## EXCEPTION REQUEST – PARK PLACE MIDDLE SCHOOL MODERNIZATION CRITICAL AREAS ORDINANCE WETLAND BUFFER REDUCTION

**RESPONSE #2 TO WATERSHED COMPANY REVIEW  
PARK PLACE MIDDLE SCHOOL MODERNIZATION  
MARCH 3, 2016**

**Existing Easement & Buildings to Remain**

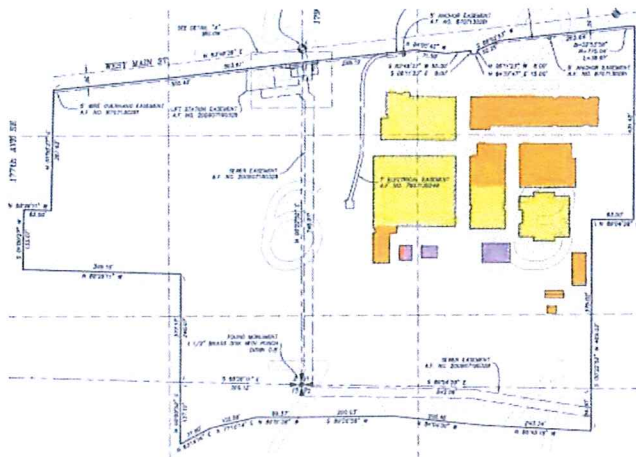
**Could the building area be reduced by building “up” or adding more stories to the building?**

The overall square footage of the school (or number of classrooms) could not be reduced without impacting the student capacity of the facility, which is needed for existing and future enrollment growth. The area of the building that could be extended to three stories is the classroom wing portion, which is on the north side of the site. The two existing buildings (gym and F Building) will remain on the south side of the new building area. The location of the existing buildings is what denotes the southern edge of structures on the site and drives the Critical Area encroachment. Additionally, existing easements on the site limit placement of new buildings. Adding a third story to the classroom wing would not move buildings further away from the wetland buffer, nor create additional useable space outside of the buffer for site and field development.

Orange: The gym (except for the southern extension) and Building F will remain.

Yellow: The sewer easement running through the center of the site and along the southern edge limits the site's building area.

The educational program is not well supported with a three story building as it would require more extensive supervision, additional building security measures, different mechanical systems, and additional fire separations. All of these elements would add to the project and ongoing operational costs – well outside of what was promised and funded by the 2015 bond measure.

#### Scheme 1

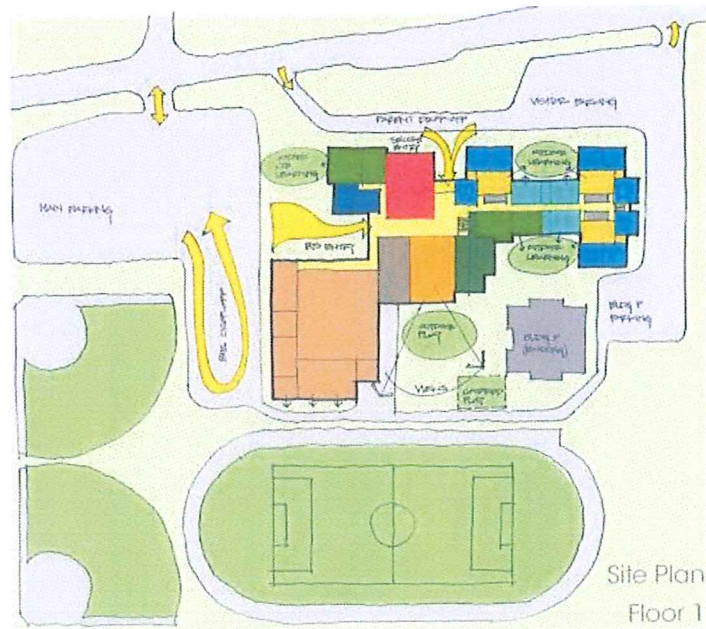
Many design scenarios and schemes were explored, yet did not meet the District's expectations for program and site development. Some of the designs that were considered (and rejected) are illustrated below:
